Addendum to the DESIGN and ACCESS STATEMENT

January 2016

This report is an addendum to the Design and Access Statement. It identifies the revisions to the design consented in March 2015.

Changes to layout

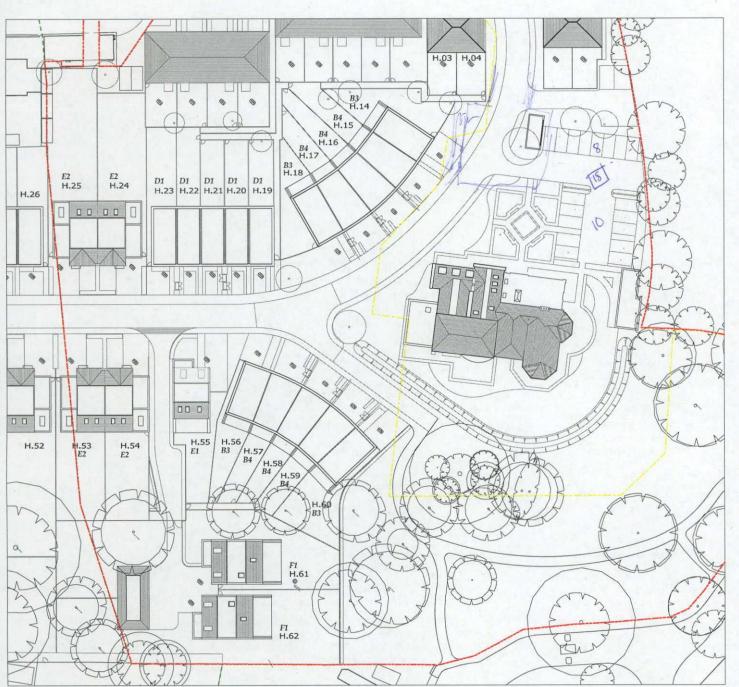
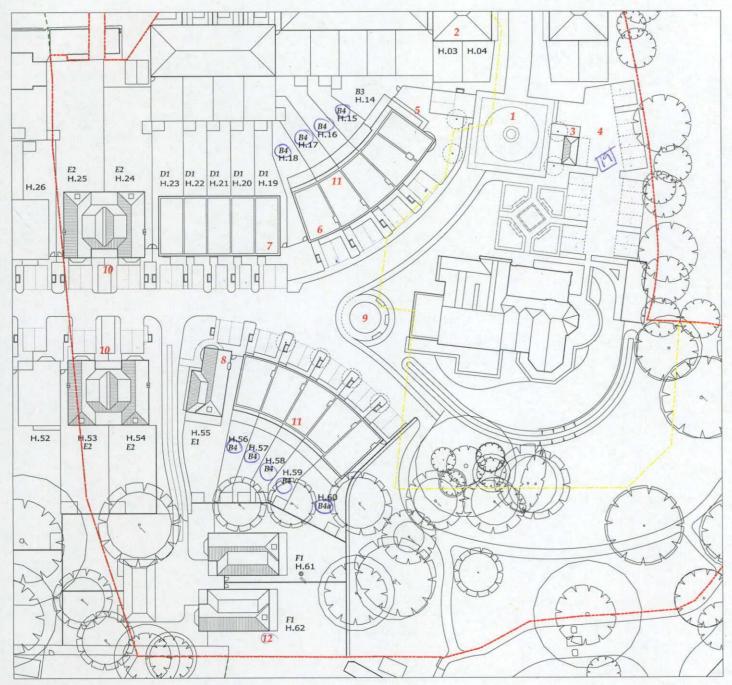
- Entrance square provided on axis with Latchmere House.
- 2. Plots H.03 and H.04 aligned with cottages opposite
- Bin store moved away from site line to Latchmere House.
- 4. Parking for Latchmere Houses maintained but moved out of site line to Latchmere House.
- 5. House H.14 redesigned to address corner location.
- Crescent geometry improved to reduce visibility of awkward side elevations.
- 7. Block H.19 to 23 moved 0.5m west to improve relationship with crescent.
- House H.55 reoriented to improve relationship with crescent.
- Landscape feature with new mature tree and seating forms focal point.
- 10. House type E2; garage removed to improve streetscene.
- 11. House type B4 has rear mansard roof, reducing top storey
- 12. House type F1 presents a better facade to Latchmere Lane

Type B3

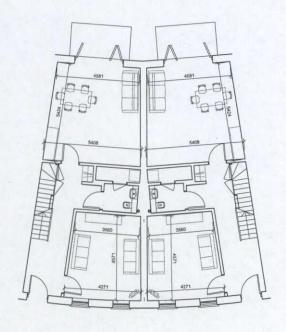
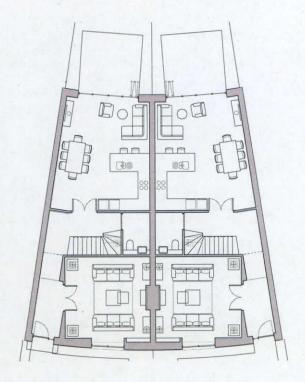
Changes to house type;

Bay window and side entrance address corner location

Internal arrangement improved

Type E2

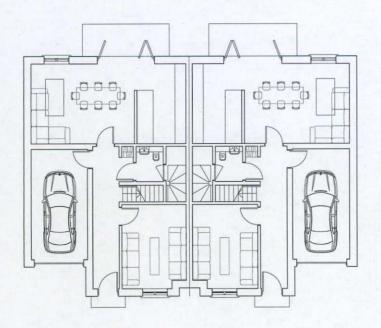
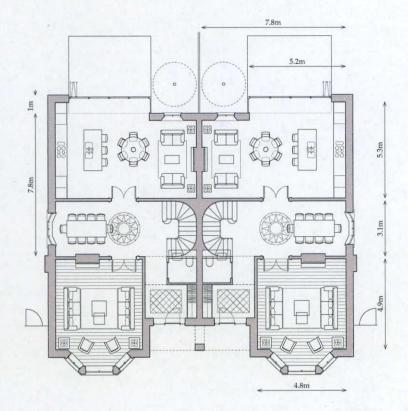
Changes to house type;

Integral garage removed; two parking spaces remain on plot.

Width reduced by 0.5m, length increased by 0.3m and a 1m extension to Ground Floor

Internal arrangement improved to provide more living space.

Roof space used more effectively.

Type B3

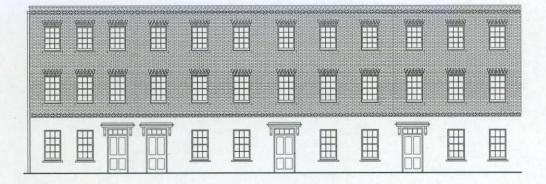
Changes to house type;

Bay window and side entrance address corner

Brick detailing enhanced
